Product / Process Change Notification (PCN)

PCN #: PCN_ConMJ_20181206
Affected Series: WE-ConMJ 615 008 140 121
PCN Date: September 06, 2018
Effective Date: December 06, 2018

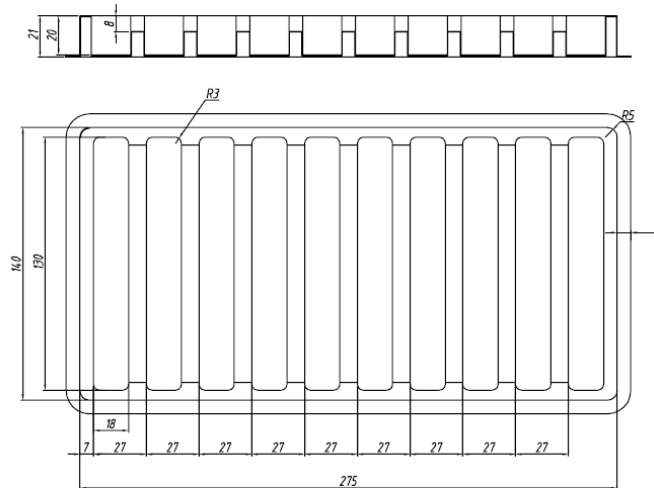
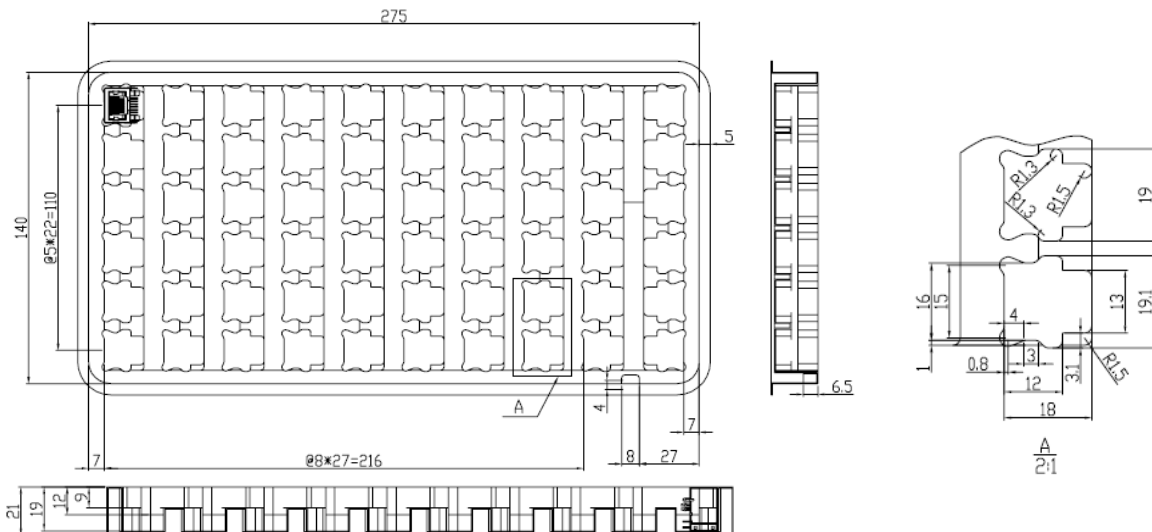
For improved transportation and handling safety, Würth Elektronik will change the packaging and standard packaging quantity by implementing a new tray design. The new trays will be formed with cavities for every single part.

The tray design will change but the size and material of the tray will remain the same. Due to this design change the standard packaging quantity will change as detailed in the table below.

P/N	Packaging	SPQ	Carton
615 008 140 121	Tray Dimensions: 285x 150 x21mm	80	3600 Dimensions: 46 x31 x31 cm 15 tray layers

P/N	Packaging	SPQ	Carton
615 008 140 121	Tray Dimensions: 285x 150 x21mm	60	2700 Dimensions: 46 x31 x31 cm 15 tray layers
